COUNCIL ASSESSMENT REPORT – MODIFICATION APPLICATION

SOUTHERN REGIONAL PLANNING PANEL

PANEL REFERENCE & DA NUMBER	PPSSTH-402 – DAM0043/2024
PROPOSAL	Modification to DA0350/2022 (Two residential flat buildings and one mixed use building comprising 155 apartments and 360sqm of retail space) – Modification to increase the number of apartments from 155 to 178, relocation of Building B basement driveway, reconfiguration of building B basement, increase of communal space, modification to facade
ADDRESS	6 Civic Avenue, SHELL COVE NSW 2529 Lot 4006 DP 1219051 Lot 4204 DP 1254978 Lot 4205 DP 1254978
APPLICANT	Australand Corporation (NSW) Pty Ltd
OWNER	Shellharbour City Council
MOD LODGEMENT DATE	30 th April 2024
ORIGINAL DA DETERMINATION DATE	Approved 22 nd June 2023
APPLICATION TYPE	Modification Application under Section 4.55(2)
REGIONALLY SIGNIFICANT CRITERIA	Clauses 2 and 3 Schedule 6 of <i>State Environmental Planning Policy (Planning Systems) 2021</i> : General development over \$30 million, and Council related development over \$5 million

The proposed modification relates solely to changes to 'Building B', on 6 Civic Avenue. The changes include an increase in the number of apartmen

Basement 2 Overall Plan

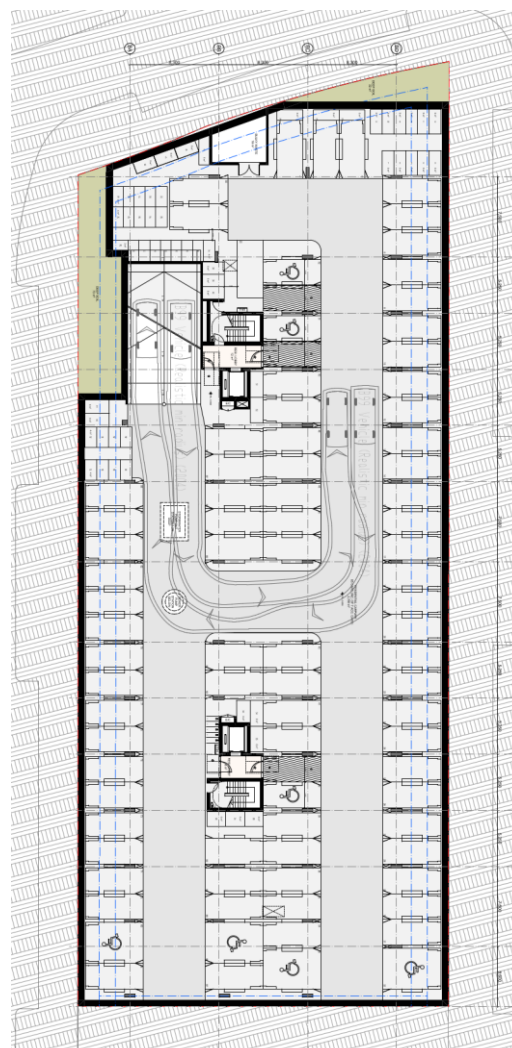
Comment: The proposed basement 2 overall plan captures the provision of additional basement parking, and a modified basement configuration. Of note, the basement entry is directed towards the centre of the build, and the basement floor area increases toward the south-east of the build.

Basement 1 Overall Plan

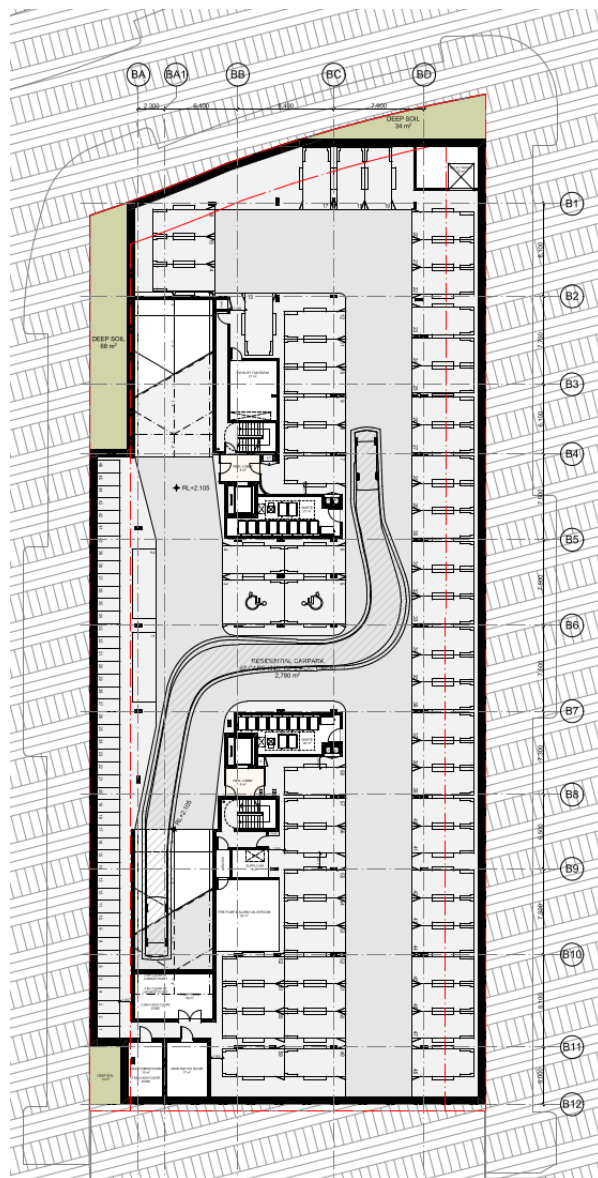
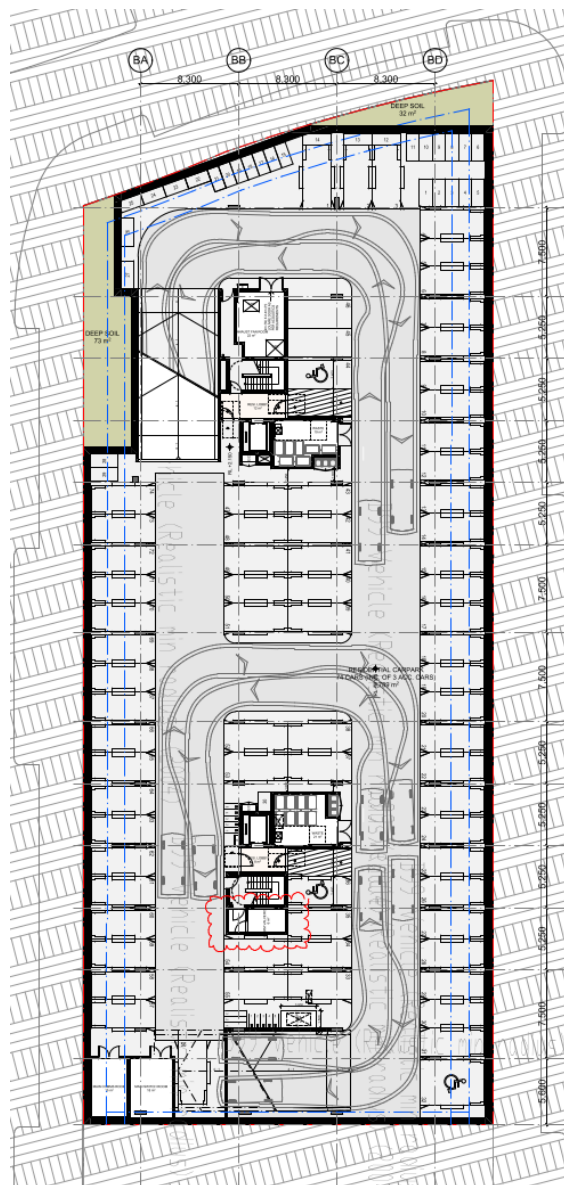
Comment: The Basement 1 Overall Plan captures changes to the basement configuration. Particularly, the entry access direction changes, as does the access to Basement 2. The west

side of Building B features an additional row of parking, and the storage compartments have been relocated primarily toward the north side of the basement 1.

Ground Floor Overall Plan

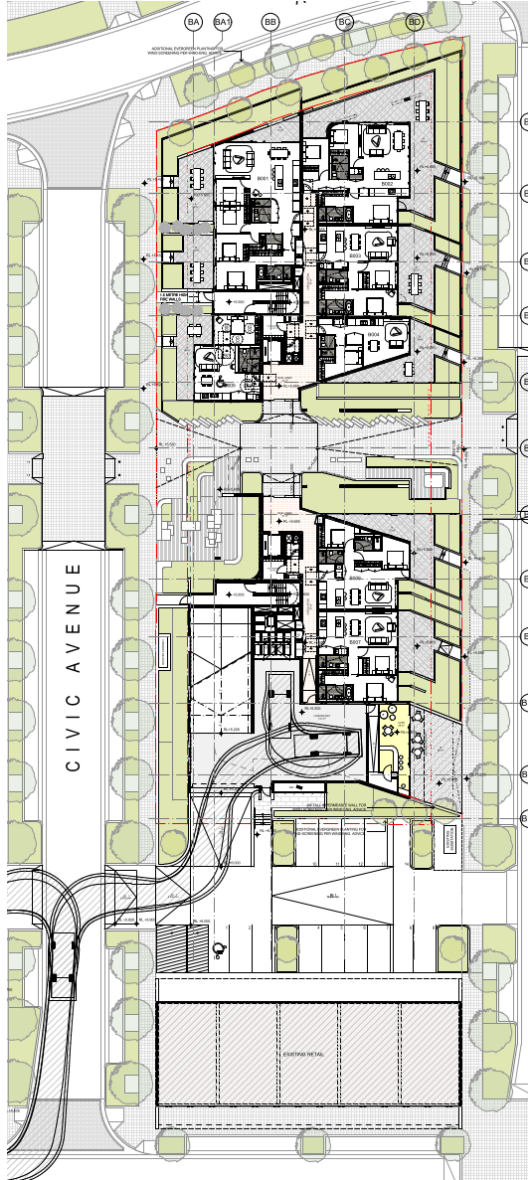
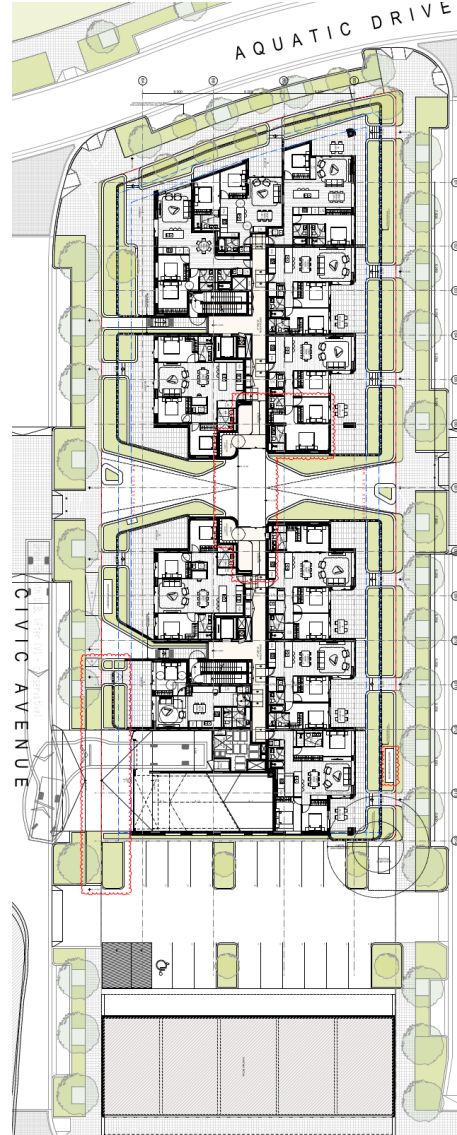
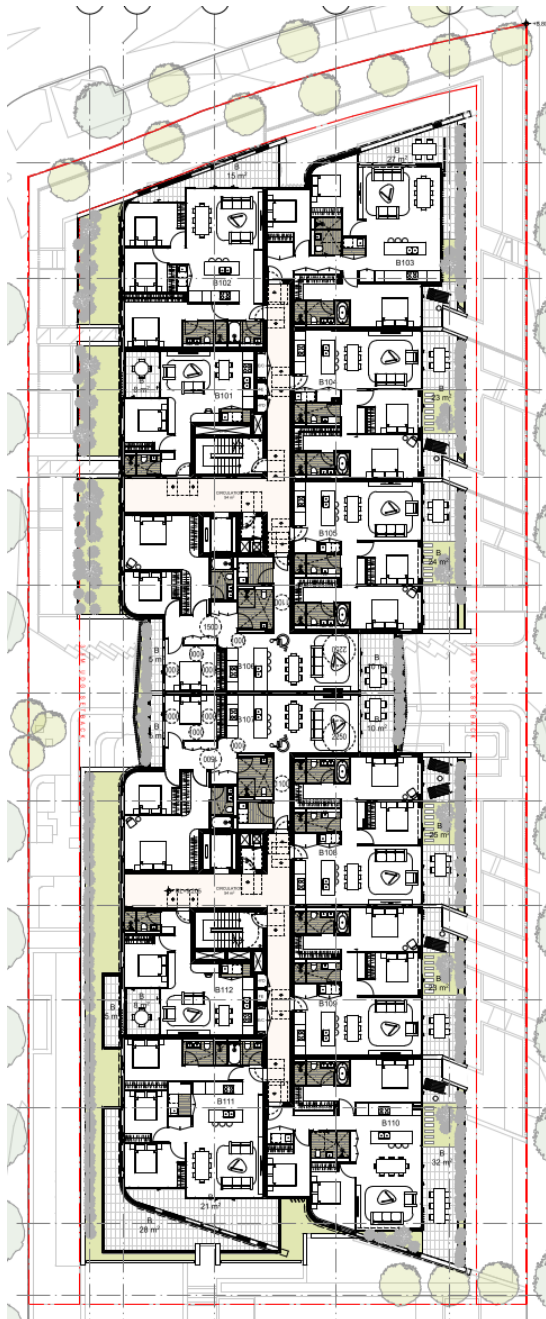
Comment: The modified ground-floor plan captures numerous details:

- The change in basement access from the open air carpark to Civic Avenue
- Change in design of the through-site access, between the north and south components of Building B.
- Change in the general floor plan configuration. This includes loss of communal open space in the south component (near the through-site access, and the cafe which was conditioned for use as communal open space. These features have been replaced with private apartment features).

- d. Changes to the architectural design located within the padmount substation easement (bottom right).

Level 1 Overall Plan

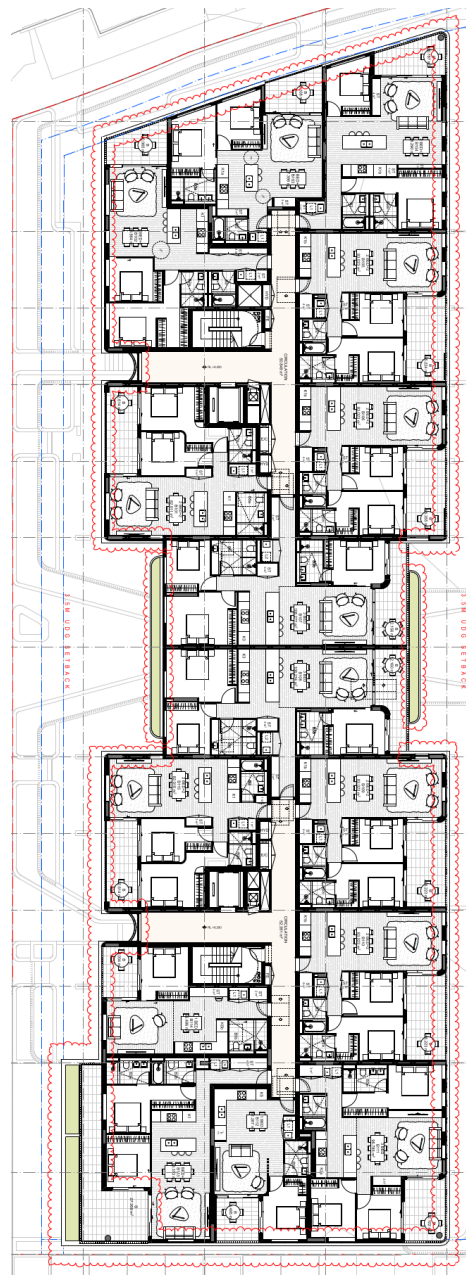
Comment: The modified Level 1 plan captures changes to the floor configuration, number of apartments, and façade details.

Level 2 Overall Plan

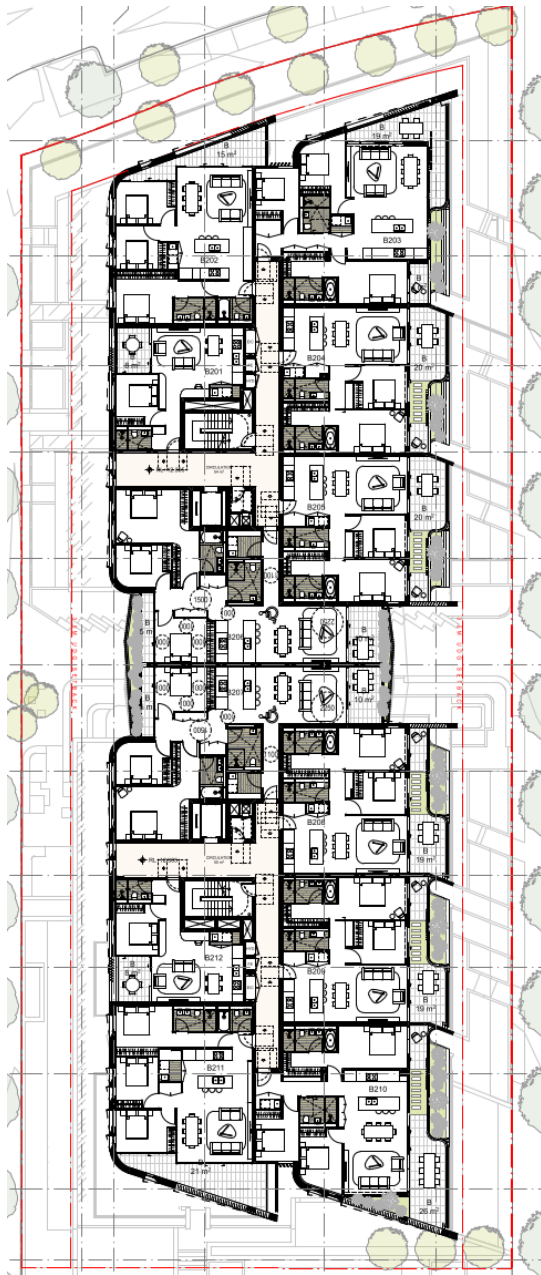
Comment: The modifications to the Level 2 floor plan capture changes to the floor configuration from Levels 2 – 4 (typical floor plate), including an increase in apartment numbers, and changes to the façade details.

Level 5 Overall Plan

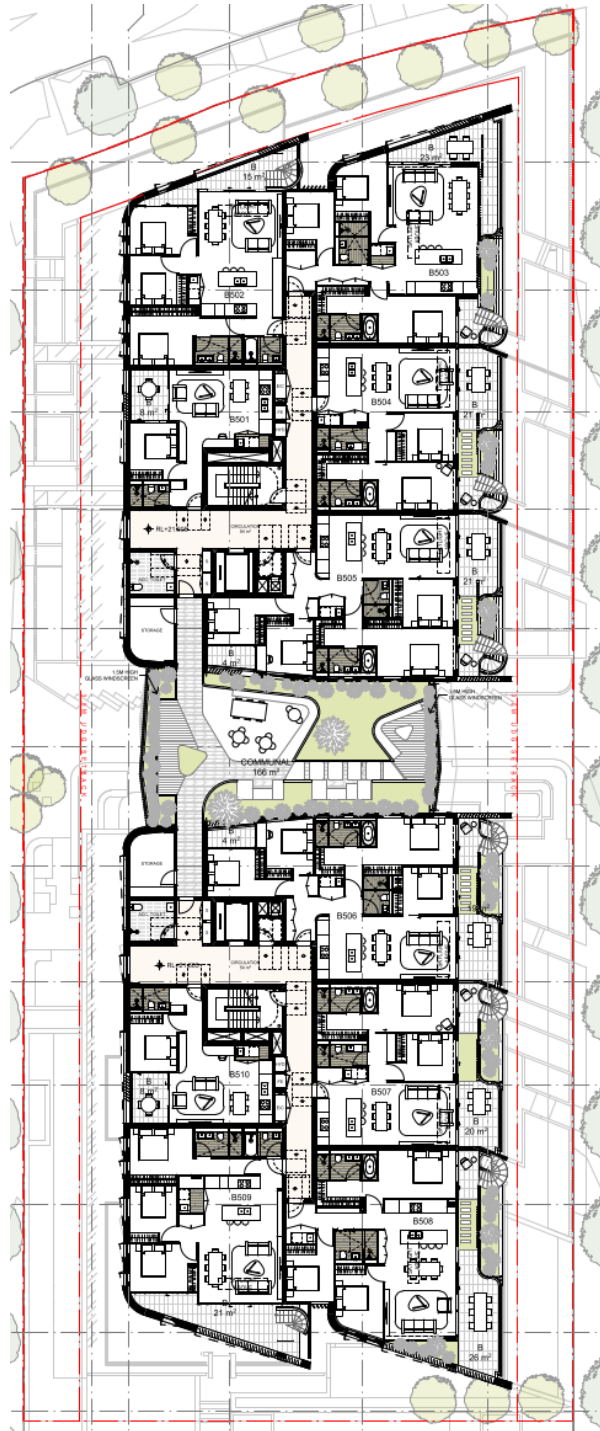
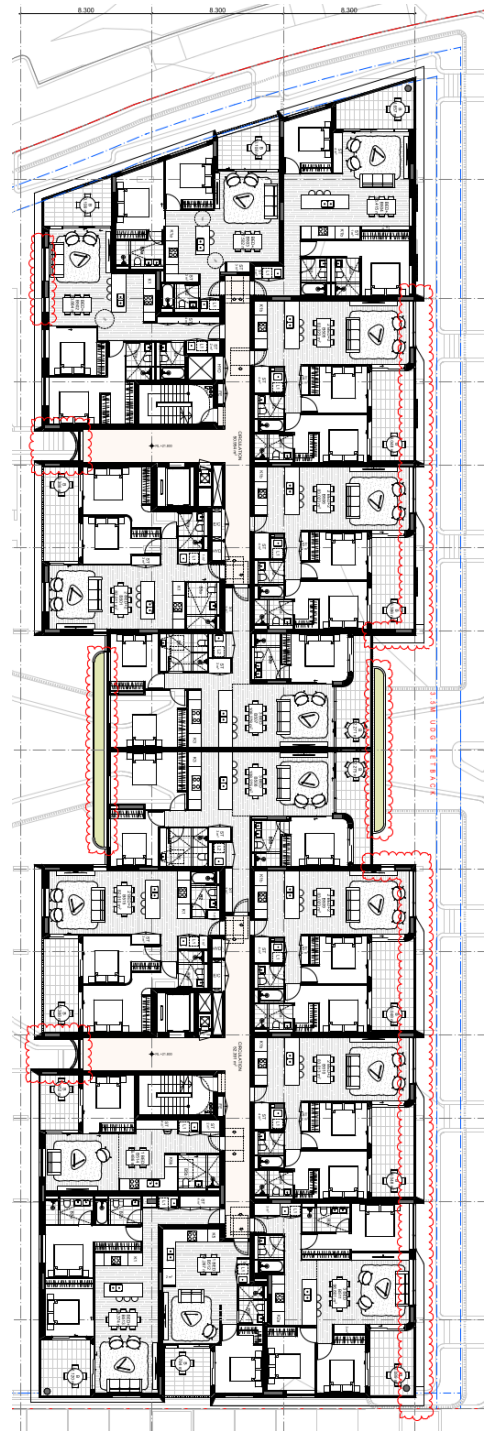
Comment: The modifications to the Level 5 floor plan captures changes to the floor configuration, increase of apartment numbers, and changes to the façade details. Notably, the modification includes removal of communal open space in the centre of the floor plan; Level 5 has been altered to reflect the floor plan of all preceding levels.

Rooftop Terrace

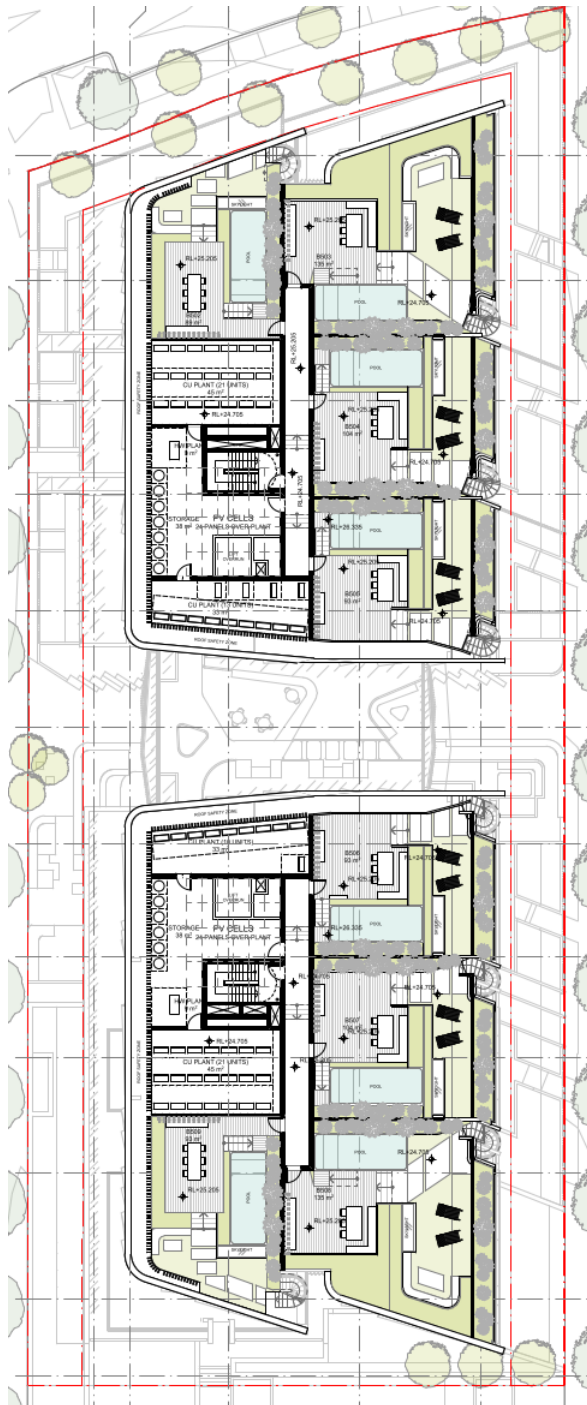
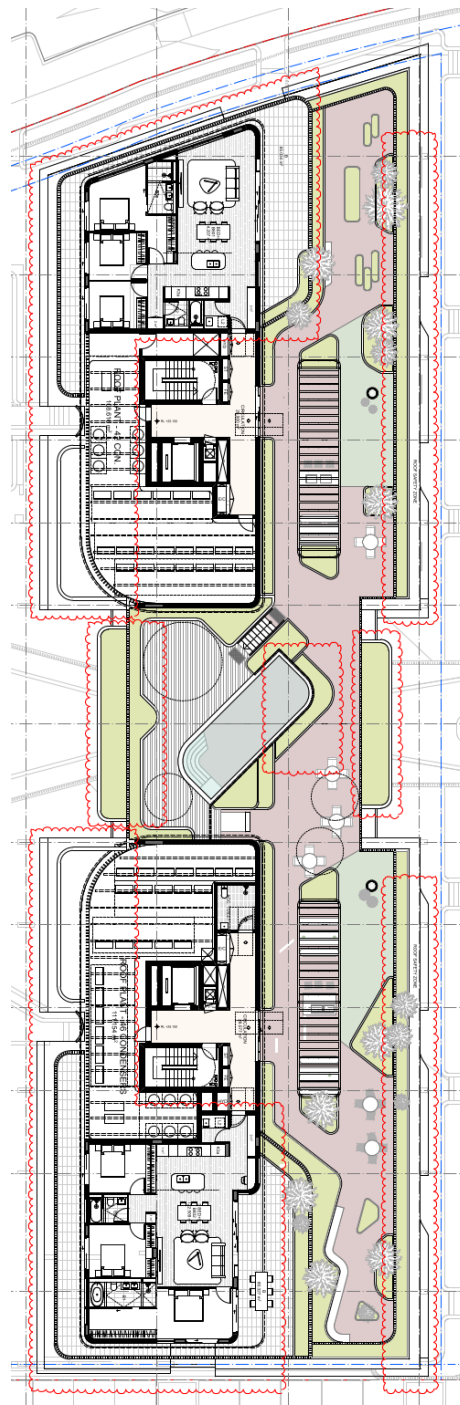
Comment: There are significant modifications proposed to the rooftop terrace. The rooftop terrace is now connected to improve accessibility throughout the building. The rooftop has been reconfigured to remove each individual POS, and introduce a larger rooftop Communal Open Space, utilising one large swimming pool and a connected communal open space with excellent amenity features.

Two 3-bedroom apartment units have also been added to the top floor.

North Elevation – Building A&B

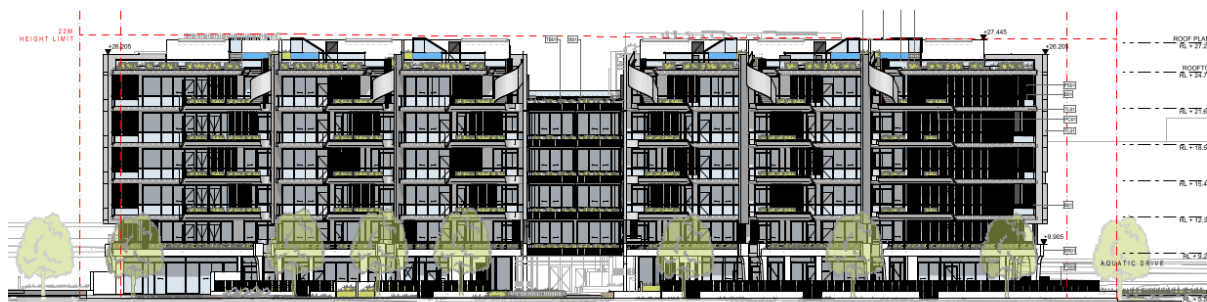
Comment: The north elevation sheet captures modifications to the north façade of Building B. The Modifications include a redesign of the façade to remove tile cladding to incorporate additional windows and articulation features.

South Elevation – Building A&B

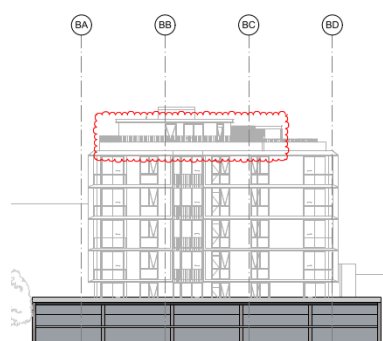
Comment: The south elevation sheet captures changes to the south façade of Building B, with the removal of some tile cladding and batten screening, replaced with incorporation of additional windows and open articulation.

Figure 7: A sketch plan provided by the applicant demonstrating the current on-street parking on Aquatic Drive (top), and the proposed on-street parking configuration for Aquatic Drive (bottom).

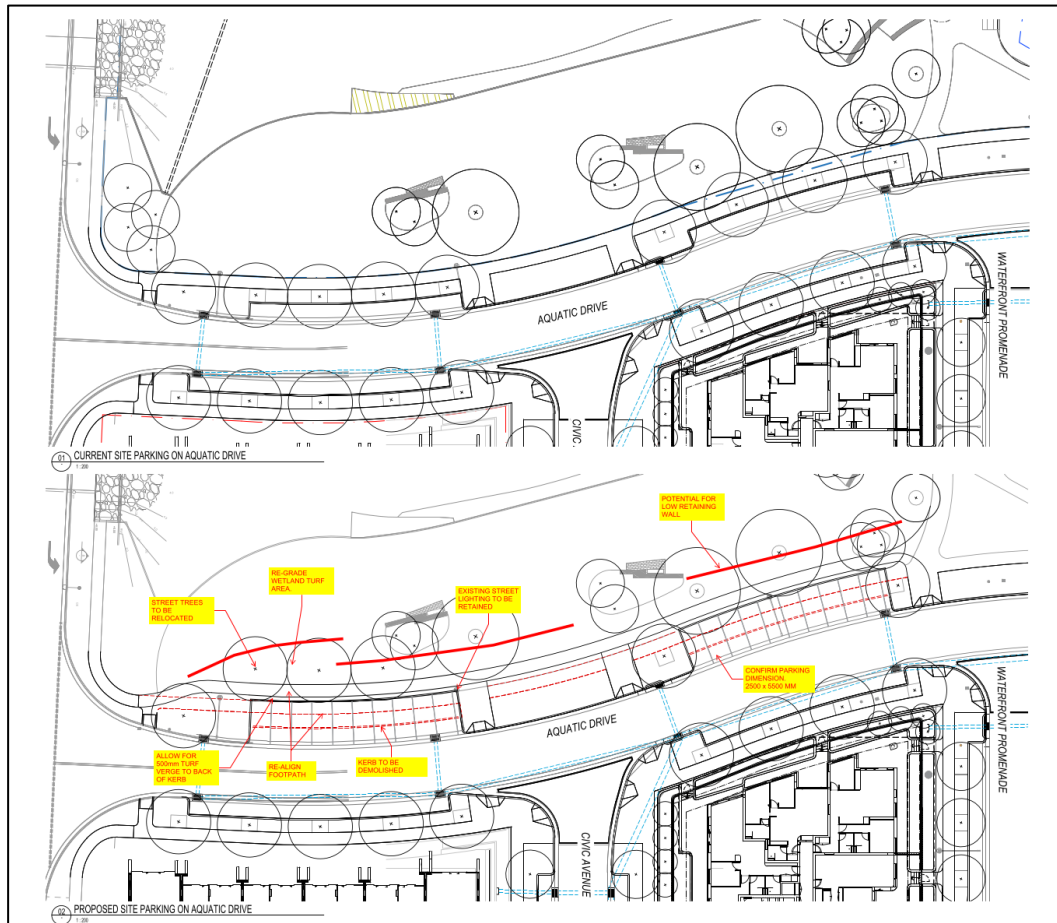
Visitor Parking Spaces	9 visitor parking space deficit in Building B as a result of proposed modification	
Total	Total deficit of 11	Total gain of 16 (net gain of 5)
